PENRITH CITY COUNCIL

MAJOR ASSESSMENT REPORT

Application number:	DA19/0432
Proposed development:	Demolition of Existing Structures and Construction of a Two Storey, Childcare Centre and Associated Carpark and Landscaping Works
Property address:	49 Gibbes Street, REGENTVILLE NSW 2745
Property description:	Lot 114 DP 1687
Date received:	28 June 2019
Assessing officer	Gemma Bennett
Zoning:	Zone R2 Low Density Residential - LEP 2010
Class of building:	Class 9b
Recommendations:	Refuse

EXISTING STREETSCAPE

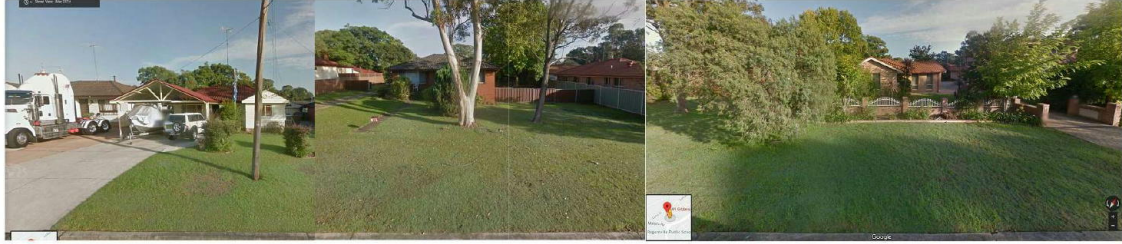
The width of the development across the lot presents a bulk and scale that is inconsistent with the existing built form in the surrounding locality. The location and design of parking areas is inconsistent with the character of the locality in which parking areas are located predominately behind the primary building line.

The landscaping treatment proposed is insufficient in area and height to provide for screening of the car park area.
